Re: Florida Power & Light Company
Proposed Turkey Point Units 6 and 7
Docket Nos. 52-040 and 52-041
Combined Information from Response to RAI 02.05.04-26 (eRAI 7811)
and FSAR Subsection 2.5.4 Grout Test Program Description

Combined Information from Response to RAI 02.05.04-26 (eRAI 7811) and FSAR

Subsection 2.5.4 Grout Test Program Description

NRC RAI Number: 02.05.04-26 (eRAI 7811)

Figure 1 Primary Grout Borehole Layout

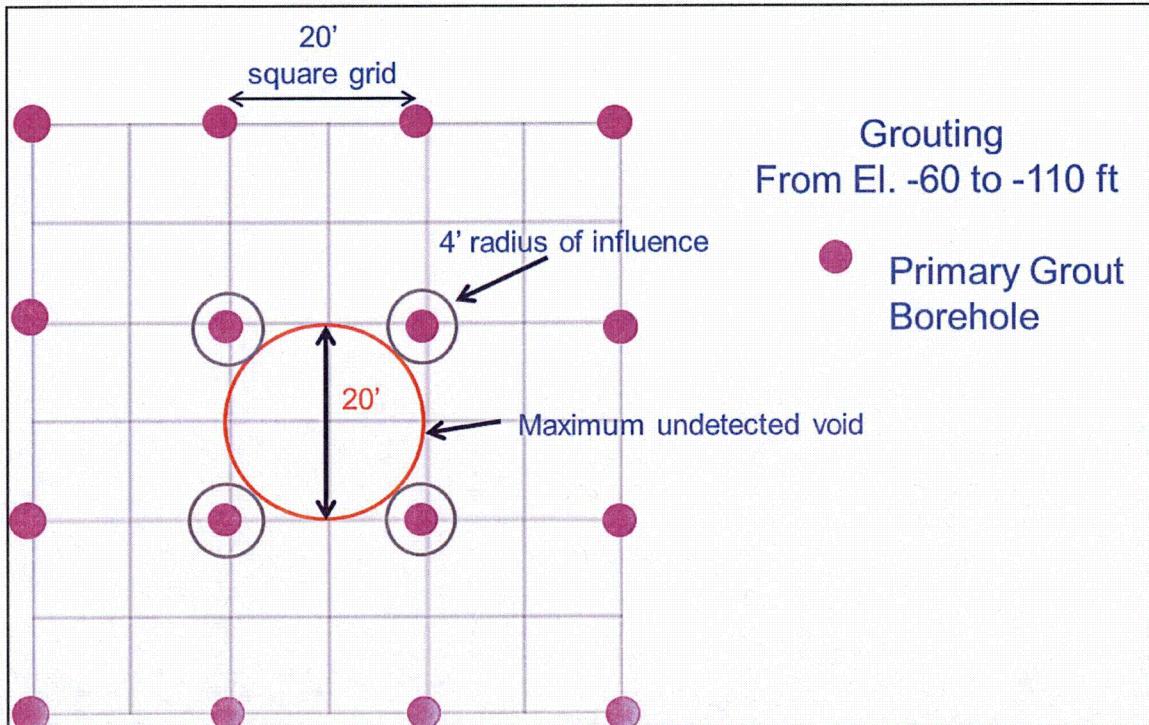
In FSAR Subsection 2.5.4.4.5.5, the applicant commits to performing microgravity surveys on the excavation surfaces of the proposed Units 6 and 7 to detect the presence, or verify the absence, of potential water-filled dissolution features (or voids) beneath the power block. Interpretations of the existing gravity survey anomalies discussed in FSAR 2.5.4.4.5.1 include uncertainties related to significant lateral variations in the shallow soil layers that will be removed prior to construction of Units 6 and 7. FSAR Subsection 2.5.4.4.5.5 states that "The [new] micro- gravity survey will be designed to detect 25-foot diameter spherical voids and cylindrical voids as small as 12 feet in diameter at the base of the 25-foot-thick grout plug at an elevation of approximately -60 feet NAVD 88." If the new gravity data (collected after the excavations are completed) indicate that there might be some gravity anomalies of concern, the applicant plans to drill those areas where such anomalies are observed to understand the source of these anomalies. In accordance with 10 CFR 100.23, please provide the following to assist NRC staff's further review in this area:

1. Clarification and demonstration that only the voids greater than the 25-foot spherical diameter and/or 12-foot cylindrical diameter at an elevation of about -60 feet are critical to the stability of subsurface materials and the integrity of structures, systems, and components (SSCs).
2. If voids smaller than the above mentioned dimensions impact the stability of subsurface materials and are critical to the integrity of SSCs, please provide further information on void size, location and depth in the limestone layers that need to be considered.
3. Additional details on the planned microgravity gravity survey specifically:

Instead of developing the critical void size via microgravity methods, which can only detect large voids at depth, the subsurface grouting program, which was planned only for dewatering purposes, will be considered in the determination of constrained void sizes. Part 4 of this response provides an Inspection, Tests, Analyses, and Acceptance Criteria (ITAAC) to ensure that the zone between El. -35 feet and El. -60 feet within the diaphragm walls (the Grouted Zone) will be grouted according to the grout closure criteria that will be developed as part of the grout test program. This grouting will result in any remaining voids in the Grouted Zone having an insignificant impact on the stability of Category I structure foundations (or are structurally insignificant). The void size defined as structurally insignificant will be determined in the grout test program. In addition, for the zone between El. -60 feet and -110 feet within the diaphragm walls (the Extended Grouted Zone), grouting will be performed in every primary grout borehole. Primary grout boreholes will be spaced less than or equal to 20 feet on center. This configuration, as shown in Figure 1, constrains the maximum undetected void size to approximately 20 feet.

The analysis considers the Grouted Zone to be completely grouted and void free. The Extended Grouted Zone will be grouted partially at primary grout holes spaced 20 feet apart. This spacing, with a conservative grout radius of influence of 4 feet, corresponds to a sphere shaped void with a maximum 20 feet equivalent diameter (as shown in Figure 1).
